HP Technical White Paper

# HP CM8060/CM8050 Color MFP - Print Usage Tracker

• This document describes the optional new page counting methodology provided by the Print Usage Tracker feature for Edgeline MFP devices.

Figure 2 – EWS Usage Page

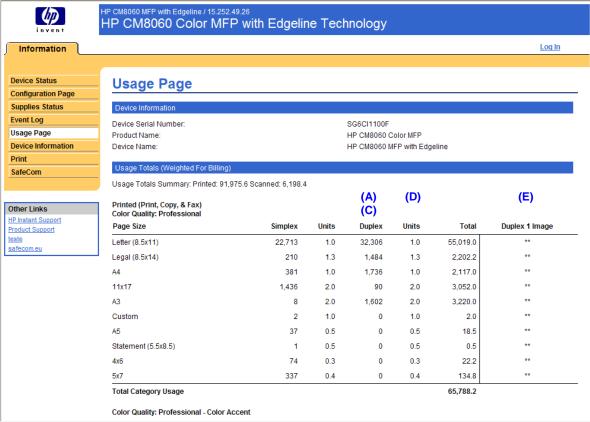
The list below provides information for which values will change and how those changes will be counted on both Usage Pages. All of the changes listed below apply to both the printed Usage Page and the EWS Usage Page. See Figure 1 and Figure 2 for sample Usage Pages with the changes noted to match the bullet points below (A, B, C, etc.).

- A) Duplex counts for each Color Quality (Professional, Professional Color Accent, General Office, and General Office Color Accent) or Black Only will count only sides where ink has been applied and will not increment for sides that do not contain ink.<sup>1</sup>
- B) Duplex counts in the Black Only table will only increment by a value of one <u>for each side</u> of a duplex sheet of paper where only black ink is applied.<sup>2</sup>
- C) Duplex counts in each of the Color Quality tables (Professional, Professional Color Accent, General Office, and General Office – Color Accent) will only increment by a value of one <u>for each side</u> of a duplex sheet of paper where color ink is applied.<sup>2</sup>

- D) The Duplex "Units" value will change to the single side Letter or A4 equivalent value (same as Simplex "Units" values) to reflect the new counting method described in bullet points A, B, and C. This applies to all Color Quality and Black Only count tables.
- E) Count values in the Duplex 1 Image columns will no longer increment and will always contain asterisks.
- F) The "Scanned (Copy, Send & Fax) section of the Usage Page will not be affected by this new functionality.

In accordance with the new methodology, specifically the changes described above in bullet points A and D, the Duplex page counts on a device will be remapped when the Print Usage Tracker feature is enabled. Values in the "Duplex" column will be doubled and values in the Duplex "Units" column will be halved to reflect the new methodology's focus on duplex sides. Values in the "Total" column will not change.
